**40GBASE-ER4**  
**proposed revision to receive**  
**power max spec**

18<sup>th</sup> June 2013

Jonathan King, Finisar

# Measurements

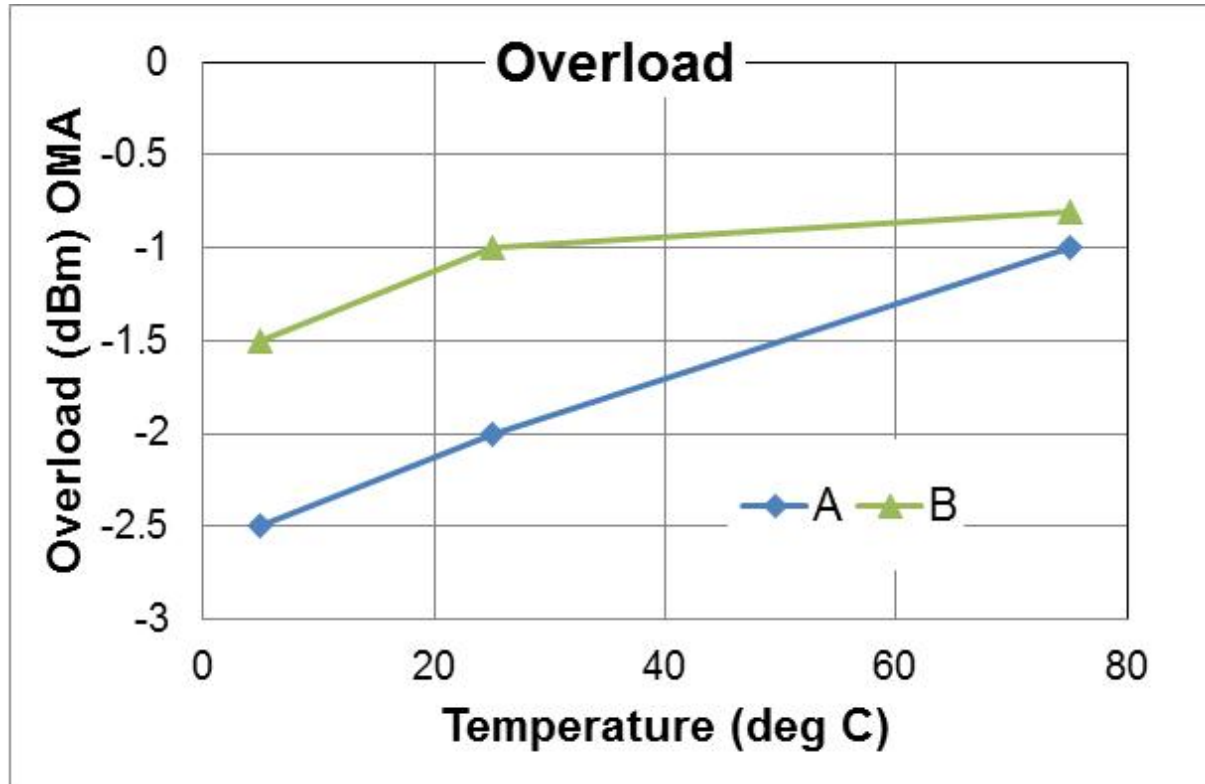
- Two 10Gb/s APD suppliers, same TIA, overload v. temperature
  - (max 2 mA 'OMA' photo-current input)
- Max input OMA, min APD gain combination, for BER= $10^{-12}$ 
  - Source ER was 5.5 dB (min specified for 40GBASE-ER4 in Clause 87 D1.0)
- Neither APD meets an overload spec of -1 dBm OMA, both meet -4 dBm OMA spec with ~1.5 dB margin
